PRODUCT BULLETIN # 16965Generic Copy

Issue Date: 05-Feb-2013**TITLE:** Announcement of a change in Design with color of 7 inch-reel**PROPOSED FIRST SHIP DATE:** The change will be made starting March 1st, 2013 when stocks of the white reels will run out and they will be replaced with the black.**AFFECTED CHANGE CATEGORY(S):** All SANYO product that is shipped with 7inch reel**FOR ANY QUESTIONS CONCERNING THIS NOTIFICATION:**

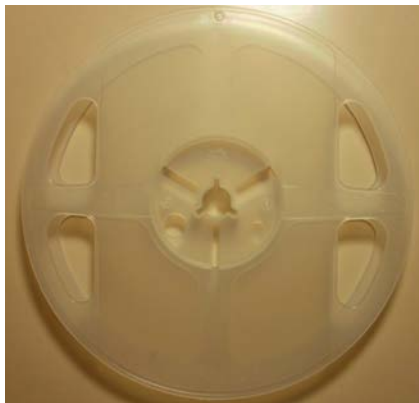
Color and shape of the window flange of the reel changes.

Dimensions and mounting hole dimensions and the material does not change.

There is no change in the number of device of this pack.
